S U P P L E M E N T A L H Y D R O G E O L O G Y
I N F O R M A T I O N

Subject: Terra Vi Yosemite Supplemental Hydrogeology Information

Geoscience has reviewed the comments to the proposed Terra Vi developments Draft Environmental Impact Report (DEIR). This letter provides supplemental information to the report submitted to you in March 2020 to respond the comments that related to source capacity testing of the Terra Vi wells.

Figure 1: Well Locations and Discharge Line

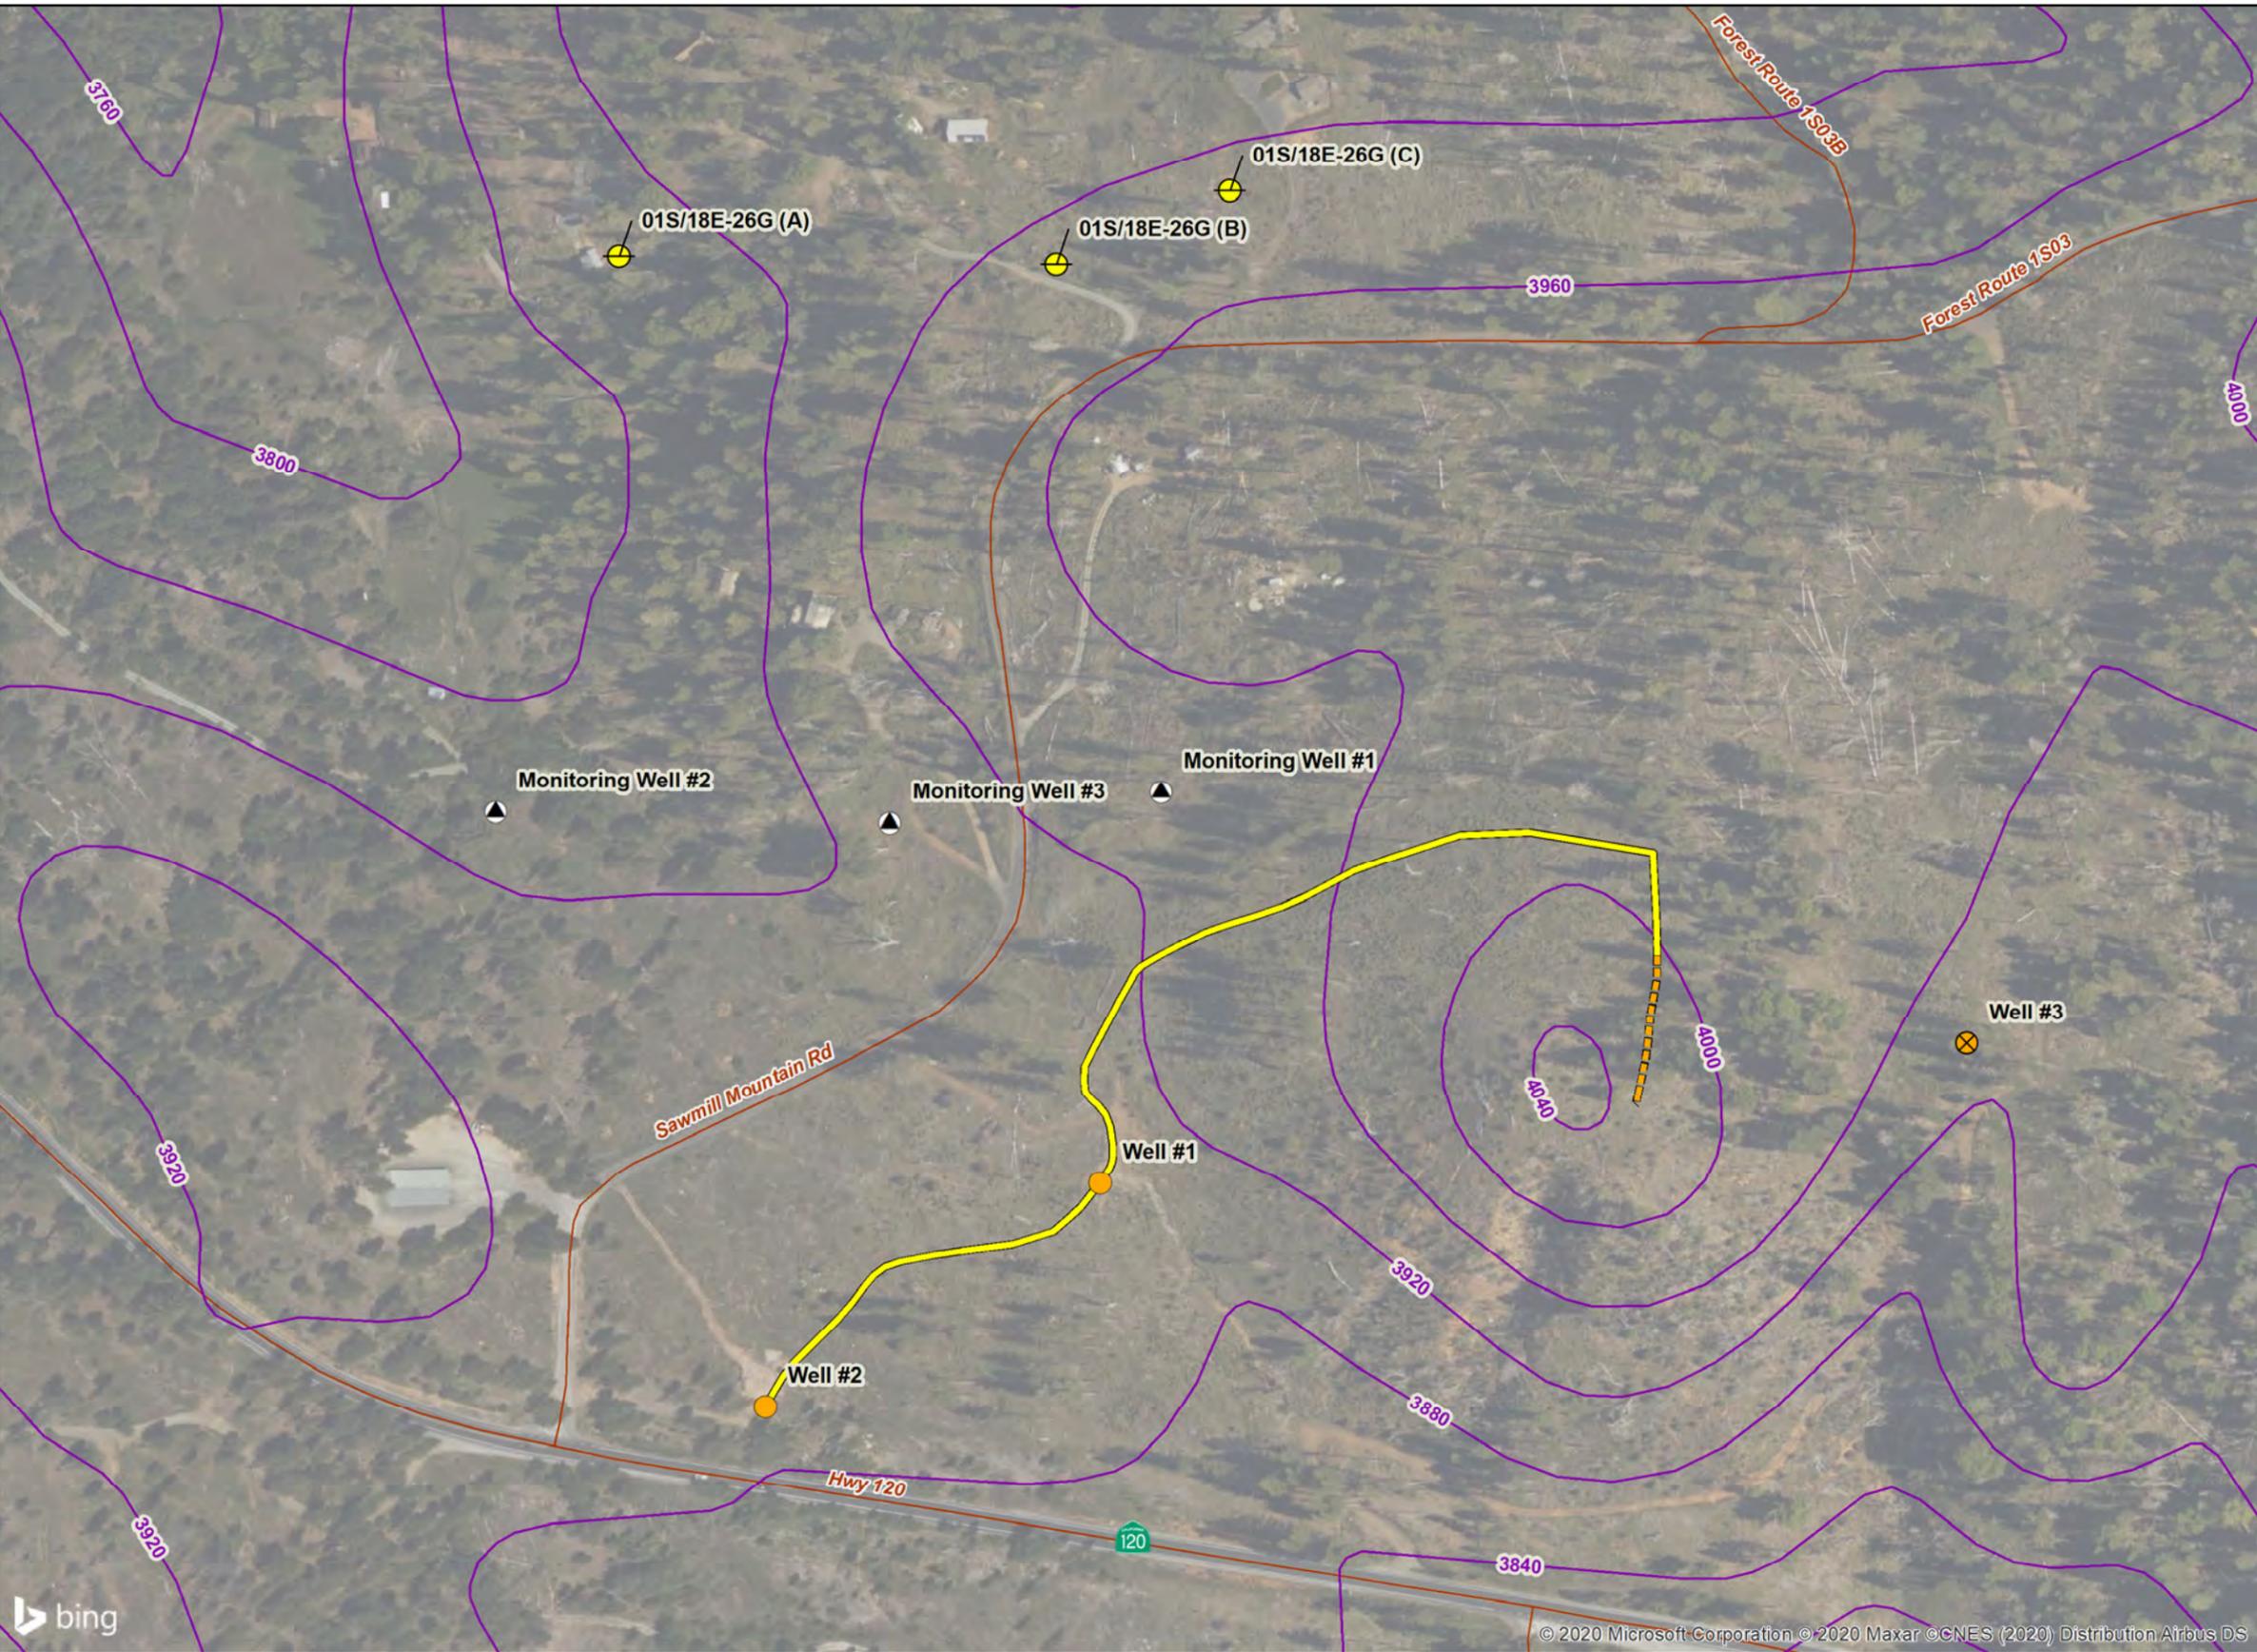
Multiple comments questioned where groundwater produced during the pumping test was discharged. The discharge point is not discussed in the report because it has no significance to the test results. The discharge point was placed east of both pumping wells separated by a bedrock knob with the land surface draining away from the pumping wells. Regardless of the discharge location, the impact of the discharge water on the pumping levels would be insignificant. Drillers logs from the Terra Vi wells indicate 50 to 100 feet of overburden consisting of silt loam, loam and decomposed and weathered granite.

The attached Figure 1 shows the location of the discharge during the pumping test.

The overburden in TV-PW-3, the closest well to the point of discharge, is 83 feet and groundwater was not encountered until a depth of 220 feet. On site percolation rates were tested at an average of 5.2 inches per hour. Therefore, water discharged at the surface would take 22 days to reach the groundwater table. The discharge from a 10-day test would have no impact on the groundwater levels.

Figure 2: Annual Precipitation and Cumulative Departure from Mean Annual Precipitation (1919-2020)
State Highway 120 and Sawmill Mountain Road

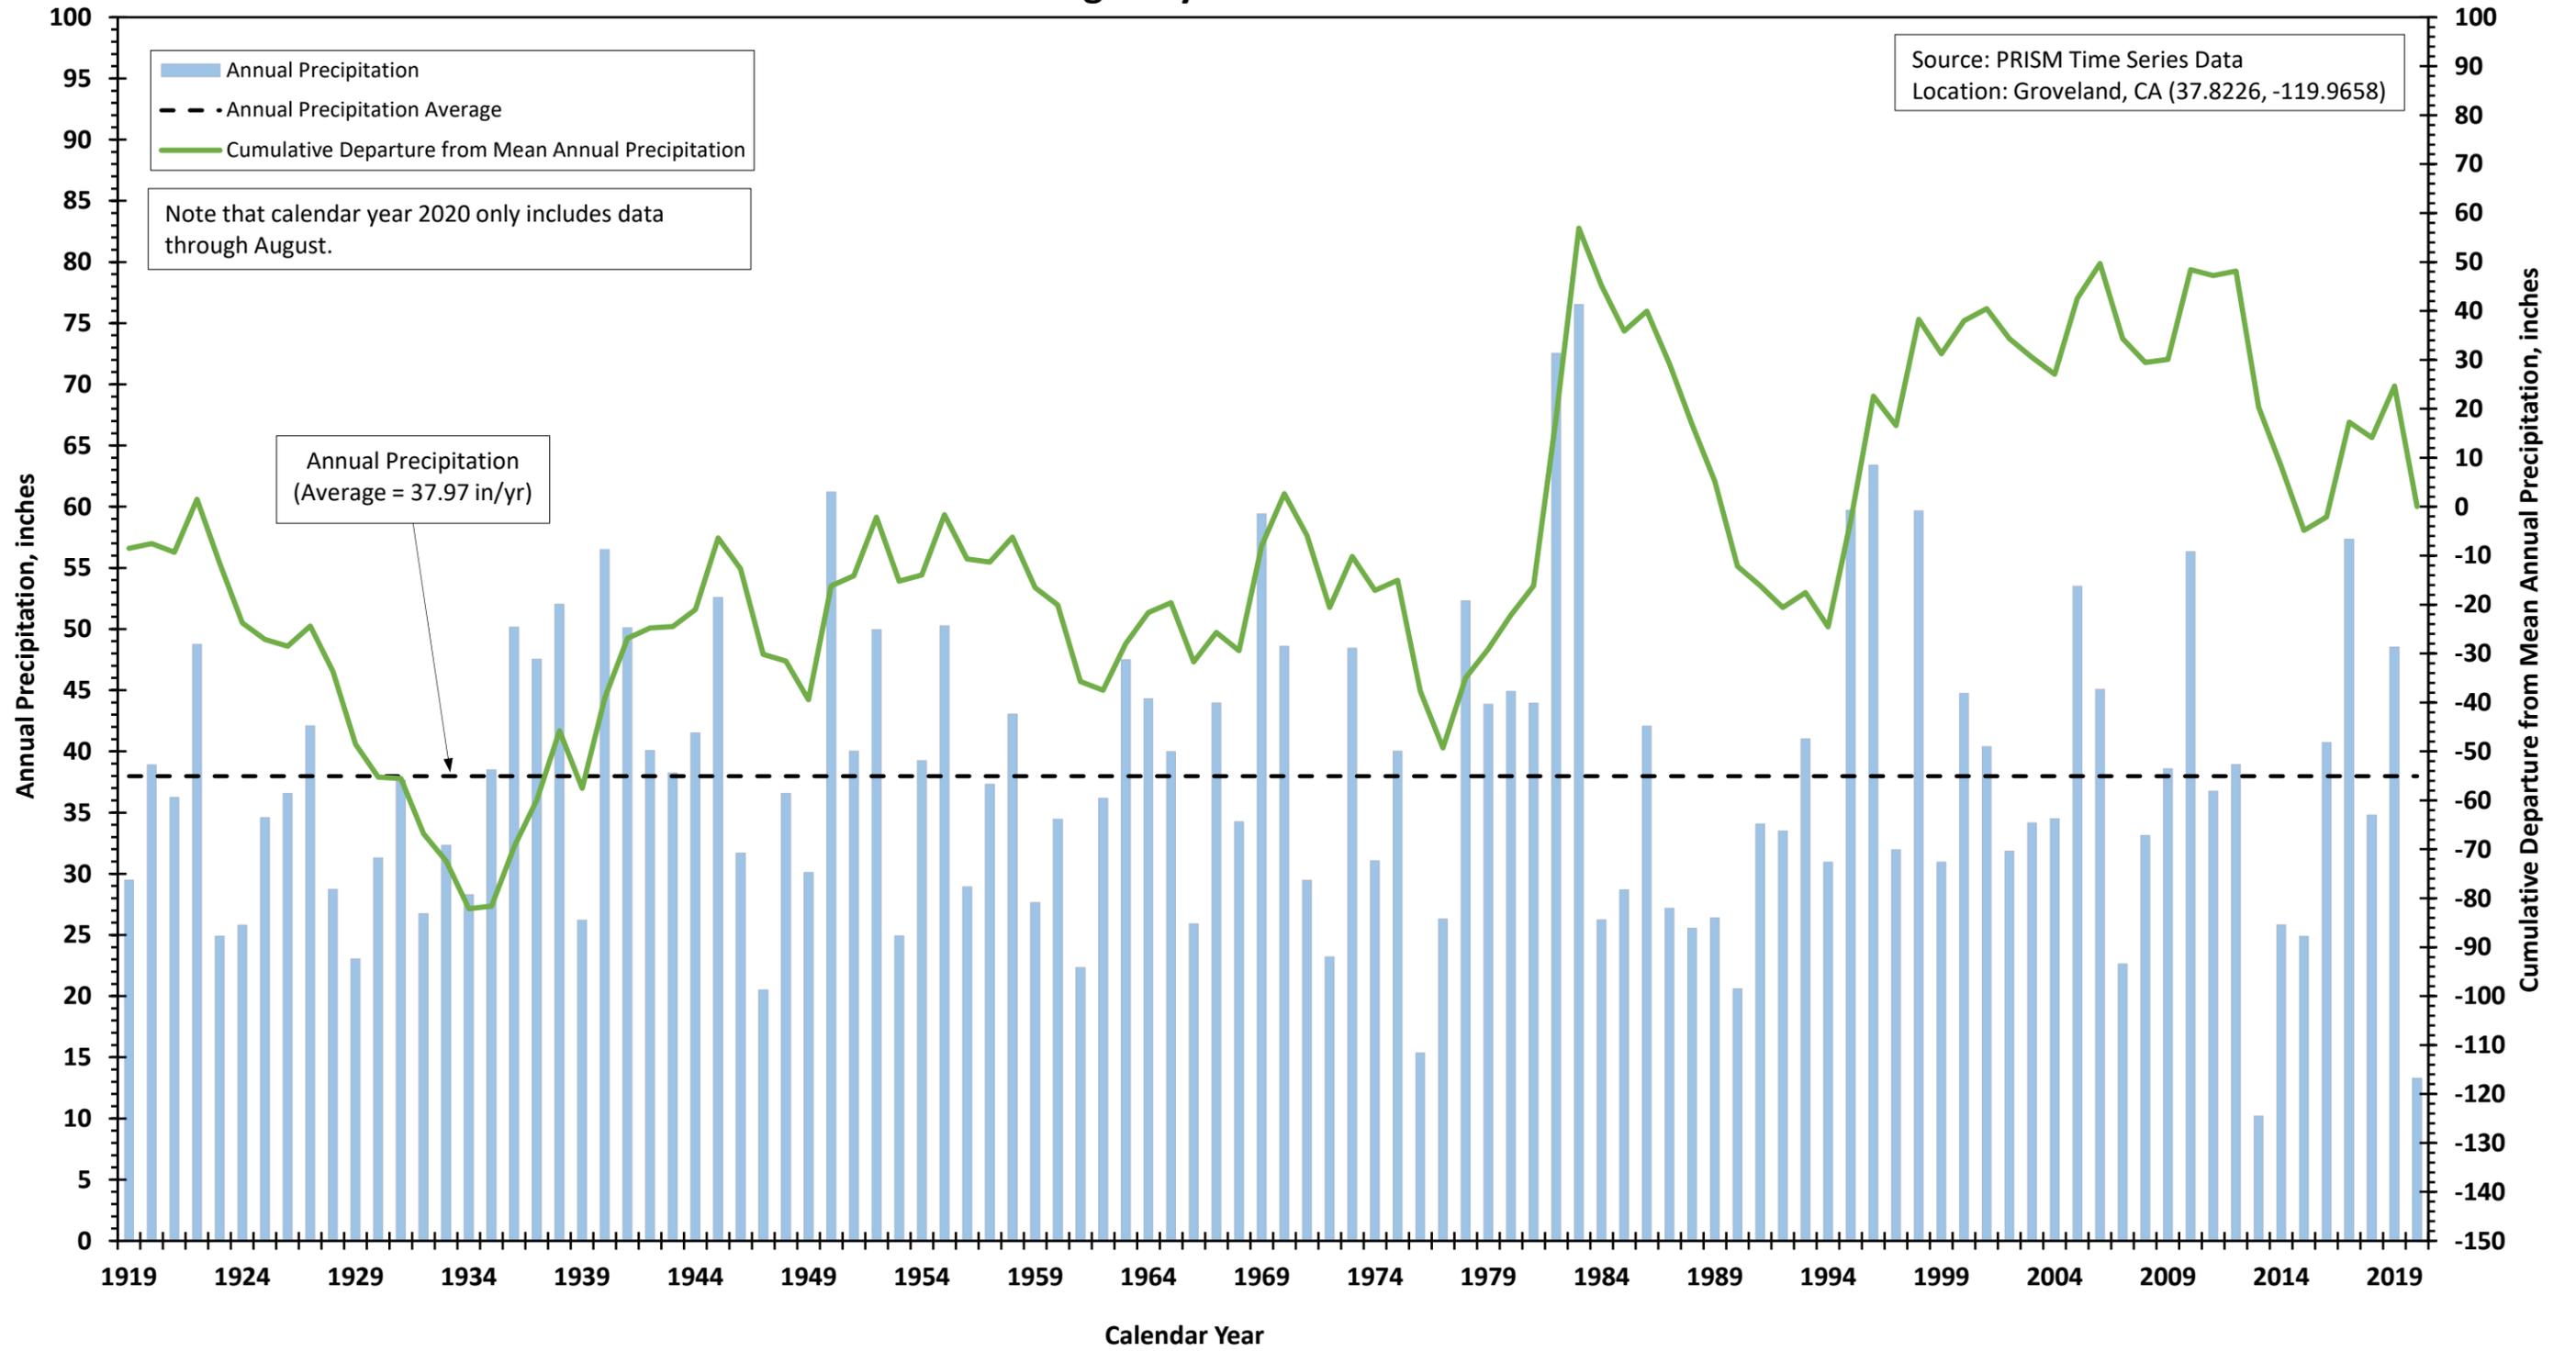
Several comments were made suggesting that testing was not valid because 2019 was a wet year. The source capacity assessment was completed in accordance with the established procedures set forth by the Tuolumne County. The County uses procedures developed by the State Water Resources Control Board (22 CAADC § 64554). The methodology selected from the County guidelines for the analysis (see Appendix C of the Geoscience report) is designed specifically to evaluate fractured bedrock (Hard Rock

Further, while 2019 was a wet year, testing was conducted in late October to Early November, which is the driest portion of the year. Rainfall in 2019 was 27% above average for an approximately 100-year record. 2020 so far is among the 10 driest years of record (over 60% below average) but water levels in the wells are a maximum of 5.24 feet below the 2019 levels. Table 1 below shows measured groundwater elevations. The attached Figure 2 shows updated cumulative departure from mean precipitation data.

The major difference in precipitation compared to the minor change in water levels demonstrates the significant volume of water in fracture storage and that the 50% factor of safety established in the State and County Protocol is both appropriate and conservative.
